# Planning Commission Staff Report June 11, 2015

CRC Oil and Gas Project  
Case No. PL13-0150

**DATE:** May 26, 2015  
**TO:** The Honorable Planning Commission  
**FROM:** Brian R. Baca, Commercial Permits Manager  
**SUBJECT:** PL13-0150, Response to Public Comment

RE: Nullification Request - Vintage Production Oil & Gas Facility, Santa Paula Canyon (PL 13-0150)

Drill site 1

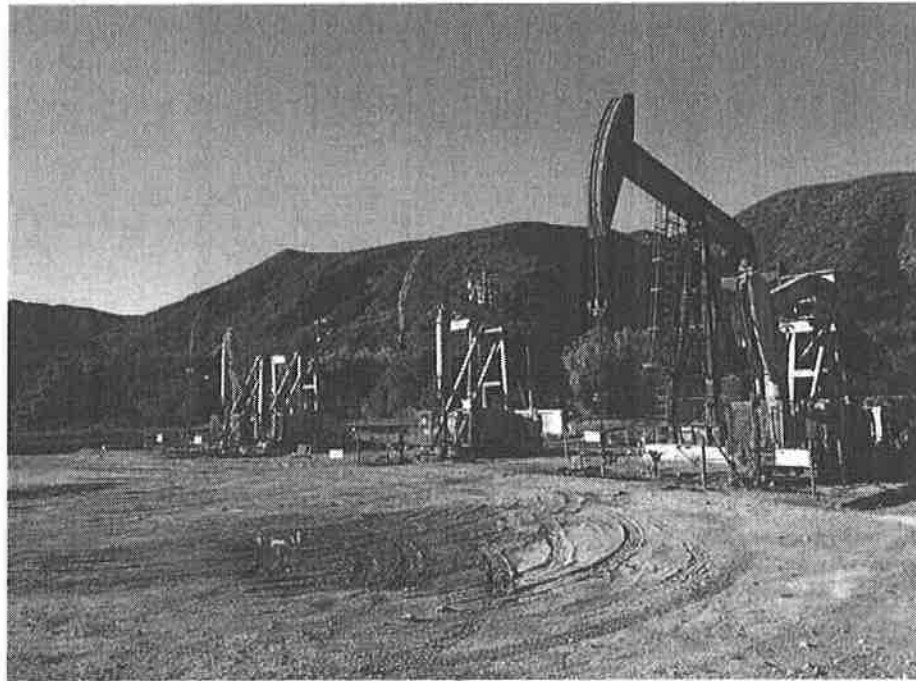
The facilities we observed at Drill Sites 1 and 7 are indeed painted, but the paint is in various stages of decay and the facilities require repainting to achieve compliance with this condition. Vintage claims in its application that the paint is "maintained" but clearly it is not, and has not been painted for several years if not decades. Moreover, the colors are not compatible with the surrounding environment (i.e. tan against a green backdrop).

6. The painting of oil field facilities is required to minimize the contrast between these facilities and the surrounding vegetated areas. Given that the hillsides may be green in the springtime (based on rainfall) and tan the majority of the year, it is not possible to have the equipment painted to match the color of the surrounding landscape at all times.
7. County staff informed representatives of CRC of the graffiti. CRC staff informed the Planning Division that the graffiti had been removed. Note that the placement of graffiti on the project site requires an illegal act of trespass. No

Graffiti at Drill Site 1

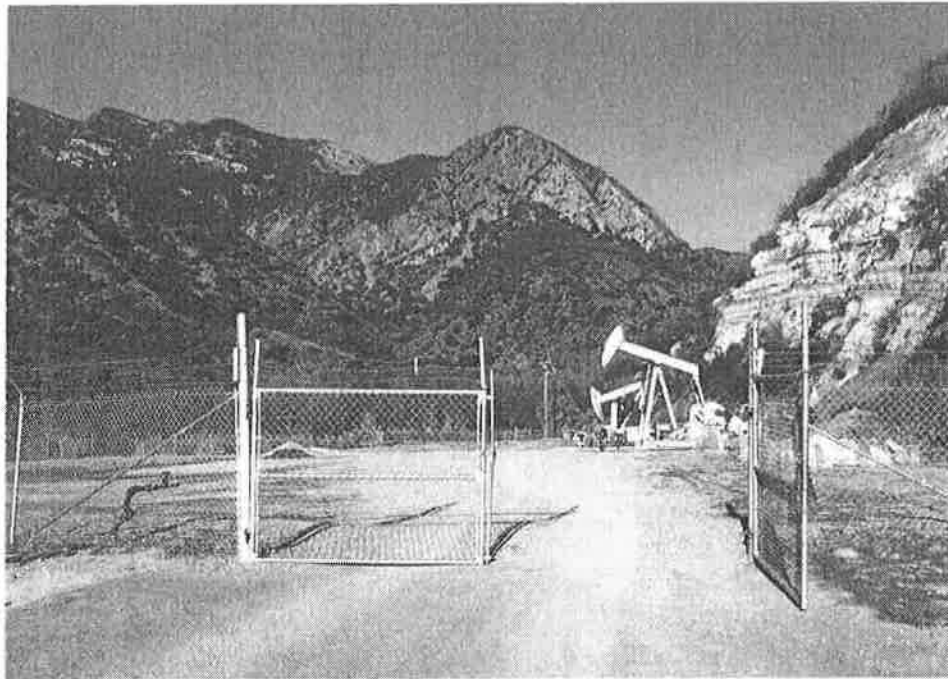
We observed unsightly graffiti at Drill Site 7 during our recent visit, in violation of this permit condition.

hazardous or unsightly conditions resulting from the operation of the oil and gas facility have been identified.

Gate unlocked at Drill Site 7

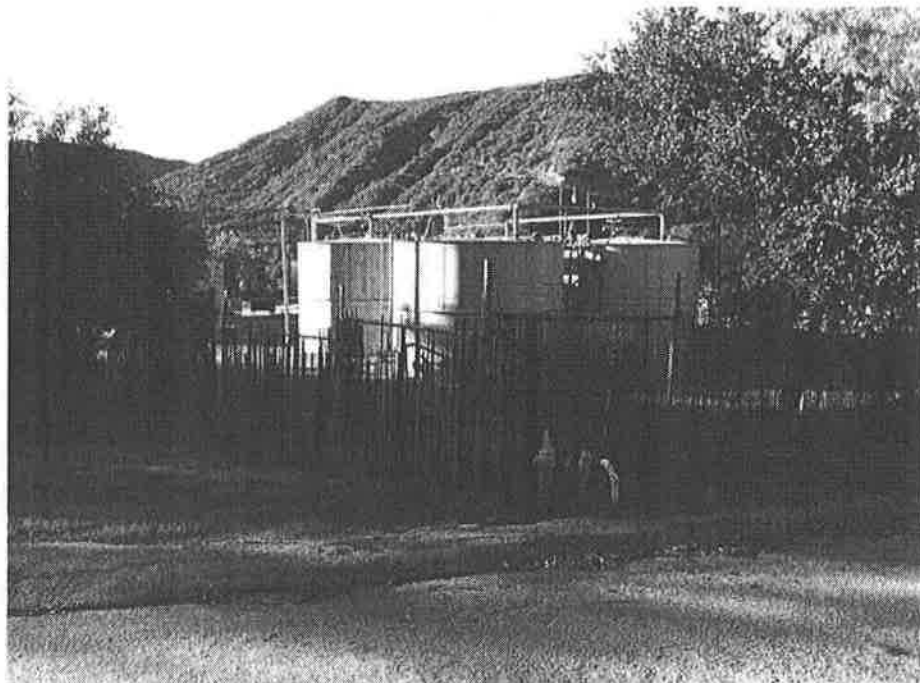
During our site visit, the gate at Drill Site 7 was unlocked and opened, in direct violation of this permit condition. No workers were present at the site during our visit. Vintage claims in its application that the gates "are locked" but this is clearly not the case.

8. County staff also observed the gate to be unlocked and informed representatives of CRC. CRC staff informed the Planning Division that the gate has been locked and the site secured.
9. A landscaping maintenance condition of approval is included in the requested permit. This condition of approval is consistent with a similar condition included in the previous permit (CUP 3344). In each case, the drillsites are to be screened from public views *"to the extent the Planning Director determines is reasonably feasible."*
